Sandia National Laboratories

Date: December 21, 2006

Subject: Error in DRZ calculation in the Clay Seam G analysis

Figure 41: Changes of the shear failure zone with time in the upper and the lower anhydrite layers of the present disposal room, $f=0.0$

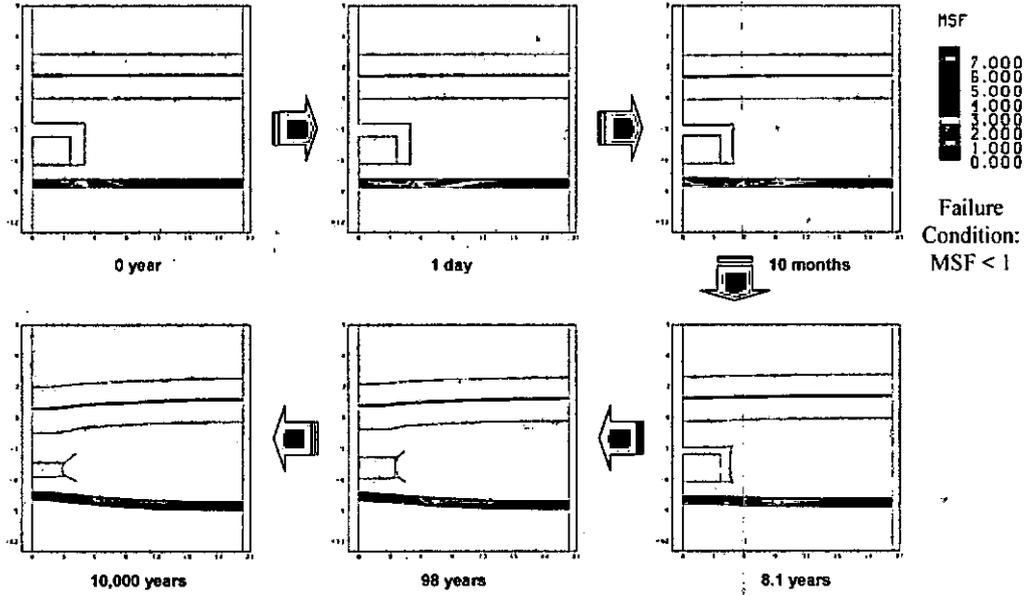
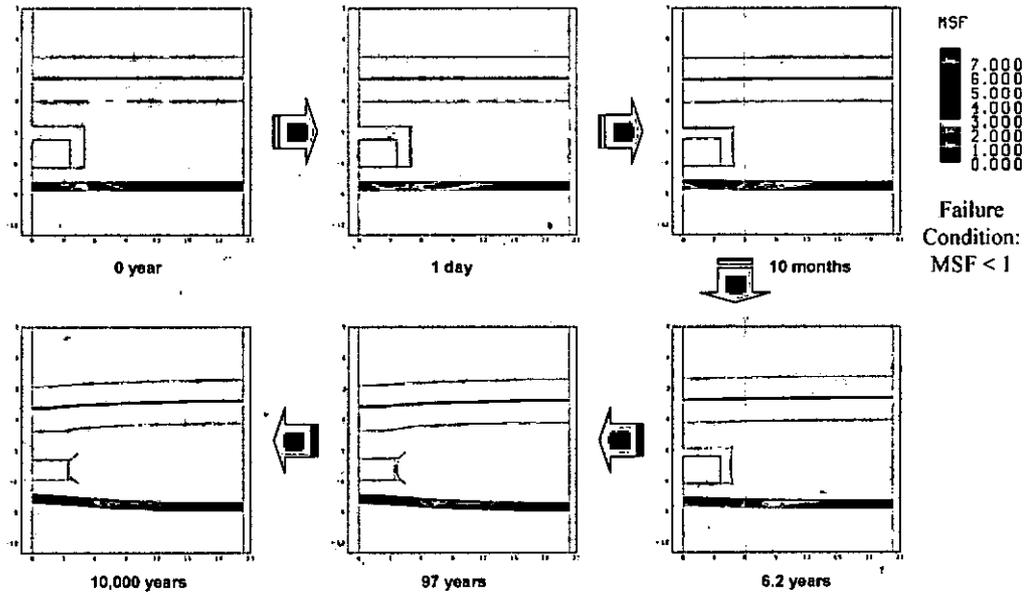
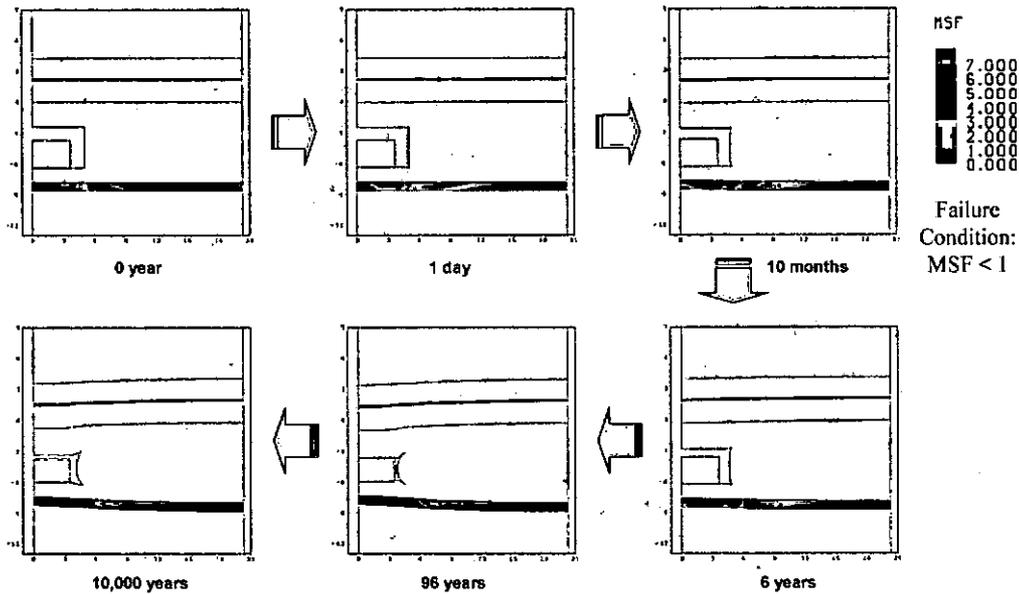
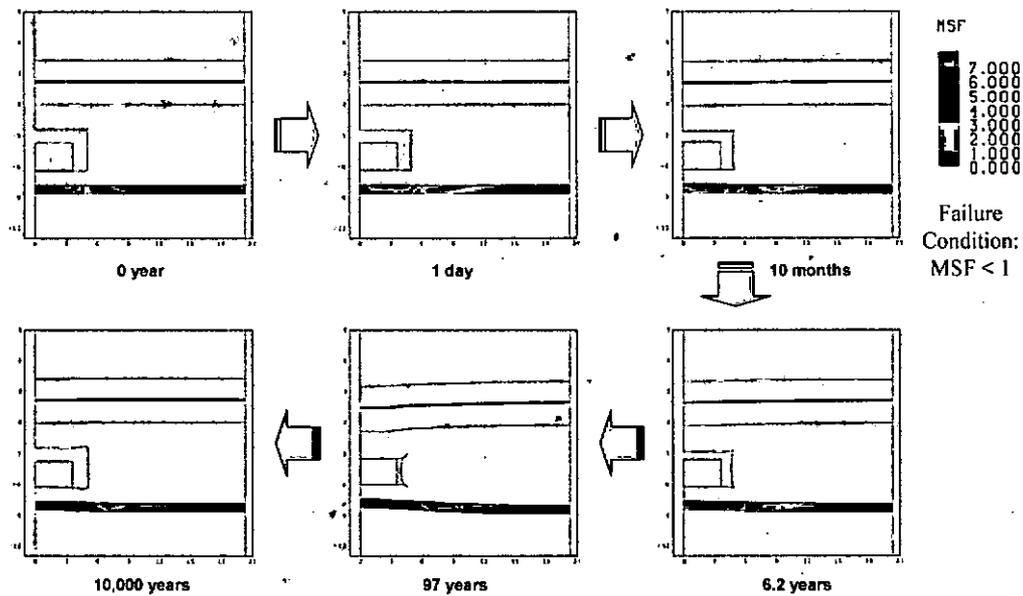
Figures 41 to 44 show the shear failure zone with time in the upper and the lower anhydrite layers of the present disposal room. The failure pattern of the present room is similar to the one of the raised room except the shear stress in the anhydrite for the present room increases faster than the raised room.

The distance between the bottom of the disposal room and the lower anhydrite layer is increased from 1.38 m to 3.81 m due to raising the room by 2.43 m. In other words, the current room is closer to Marker Bed 139. Because of this, the deformation of the anhydrite layer with the room closure is larger for the current room than the raised room. The shear failure zone is accordingly larger for the current room as shown in Figure 37 to 44.
